CITY OF ANTIOCH ZONING ADMINISTRATOR

**STAFF REPORT TO THE CITY OF ANTIOCH ZONING ADMINISTRATOR
FOR CONSIDERATION AT THE MEETING OF JULY 13, 2017**

Prepared by: Kevin Scudero, Associate Planner
Reviewed by: Alexis Morris, Planning Manager
Date: July 7, 2017
Subject: V-17-01, AR-17-03 Jack In The Box Remodel

PROPOSED
 EXTERIOR
 ELEVATIONS
A2.3

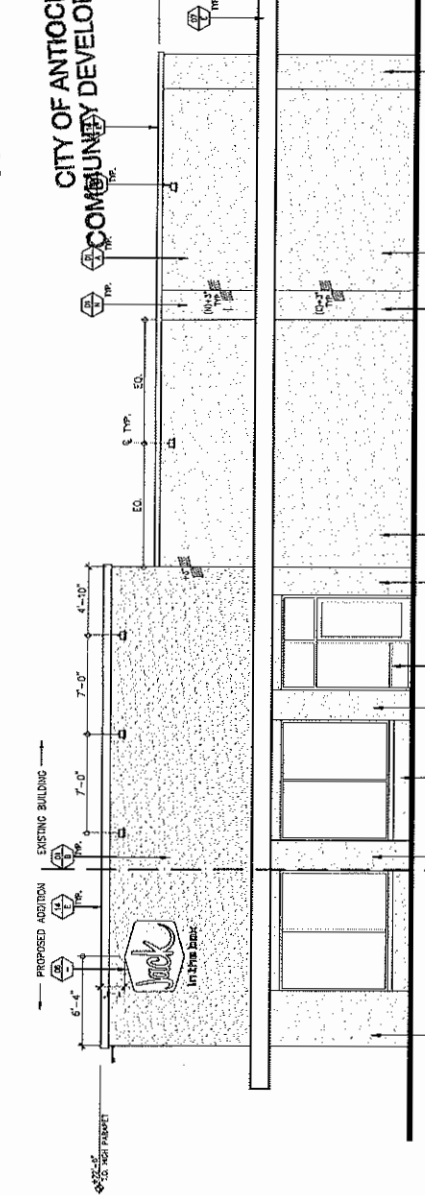
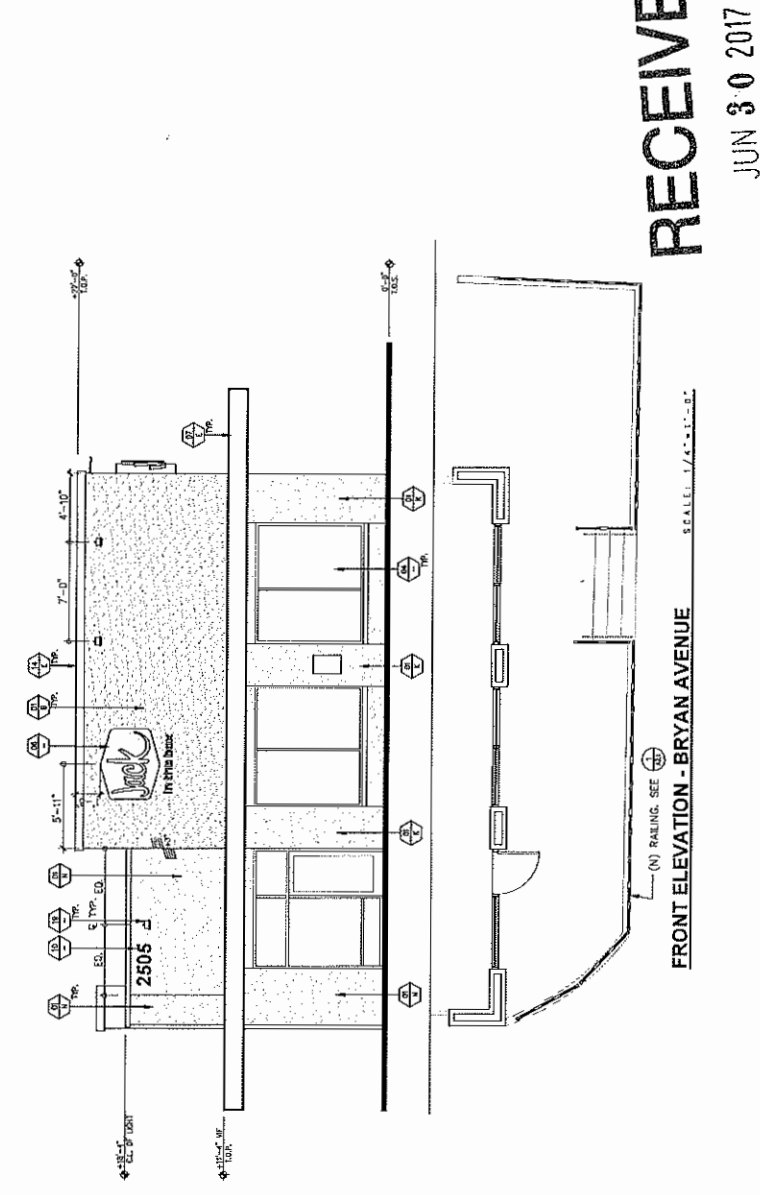
The proposed building signage shows three “Jack In The Box” logo signs. The signs are located on the north, east, and west elevations. Section 9-5.512 of the Antioch Municipal Code only allows signage to be placed on the sides of the building that have street frontage. Therefore, staff has conditioned that the sign on the east elevation be removed.

The project is proposing new LED lights on the façade; however, the lighting details that were submitted were not compatible with the overall design of the building. Staff has conditioned that more substantial decorative lighting be installed. The review and approval of the exterior building lighting will be done with the building permit submittal.

1. This variance and design review approval applies to the exterior remodel and 462 square foot building addition at Jack In The Box Restaurant at 2505 A Street as depicted on the project plans submitted to the City of Antioch on April 4, 2017 and the updated elevations submitted to the City of Antioch on June 30, 2017.
2. The proposed "Jack In The Box" sign on the east elevation shall be removed.

4. The masonry wall on the east property line shall be painted "Repose Gray" to match the building.
5. The exterior wall lighting shall be more substantial and decorative. New lighting details shall be submitted with the building permit plans and are subject to Planning staff approval prior to issuance of building permits for the project.

7. The parapet walls shall be constructed as depicted in the updated exhibit submitted to the Planning Division on June 30, 2017 and included in the elevations as Attachment C.

8. The rear of all parapets shall be finished in same colors and materials as the exterior of building.
9. Any cracked or broken sidewalks shall be replaced as required by the City Engineer.
